Product Change Notification (PCN)

Note: While responding, please retain "**PCN Notification:503383**" in the e-mail Subject line for faster response.

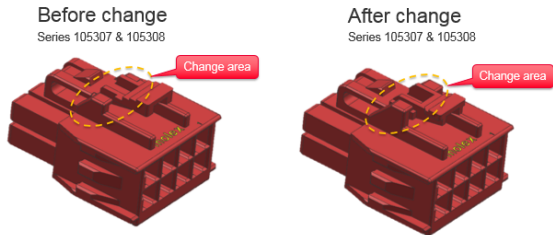
Change Nano-Fit receptacle to enhance structure of **change area**, no impact for fit or function.
